Service Bulletin No.: DAC1-24-03 Rev 2

Title: G-35 Battery, Optional Installation

Figure 1

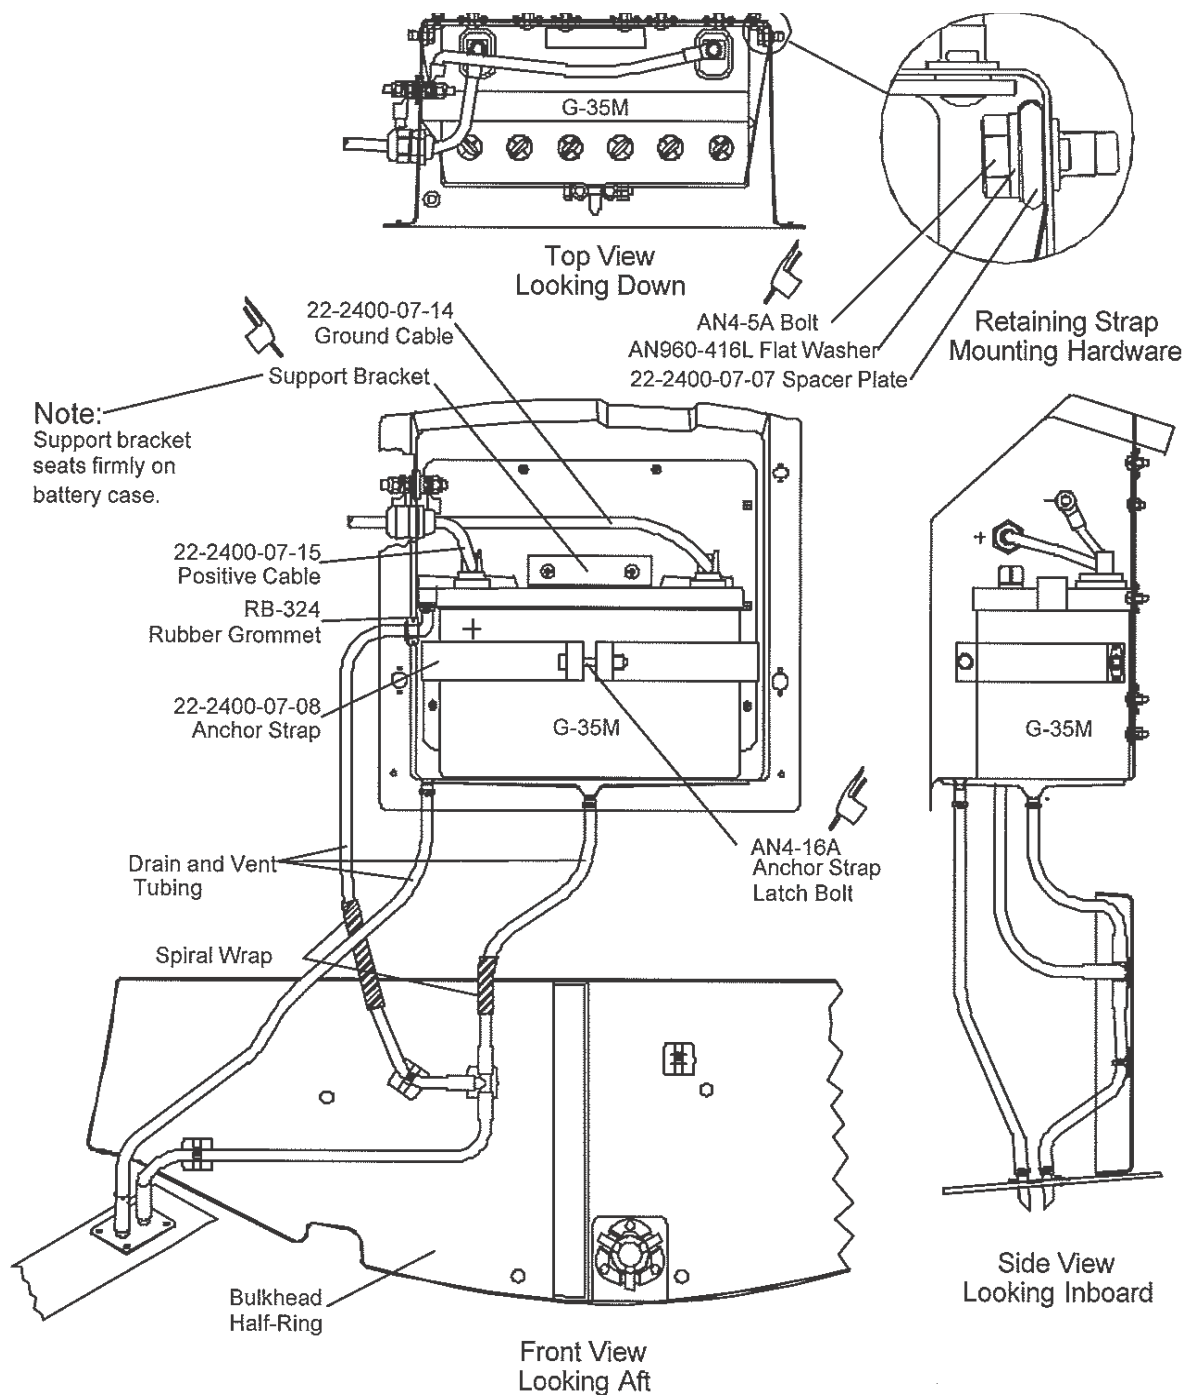
- 10.4 Remove the rubber plug from right side of battery housing and install the new rubber grommet as in Figure 1.
- 10.5 Reroute the vent and drain tubing as in Figure 1.

- 10.6 Install the new anchor strap mounting hardware as in Figure 1.
- 10.7 The new positive cable terminal has a larger diameter (5/16"Ø) ring terminal at the battery end. Do one of the following procedures:

- 10.8 Install the new rubber plug in the left side hole in the battery housing.
- 10.9 Install the new battery (reference DA201-C1, chpt. 24-31, sec. 3B). Discard old anchor strap latch bolt and install new bolt P/N AN4-16A as in Figure 1.

- 10.10 Install the support bracket. Elongation of the housing holes may be necessary for proper fit on the battery (see Note in Figure 1).
- 10.11 Update the Airplane Flight Manual weight and balance record.
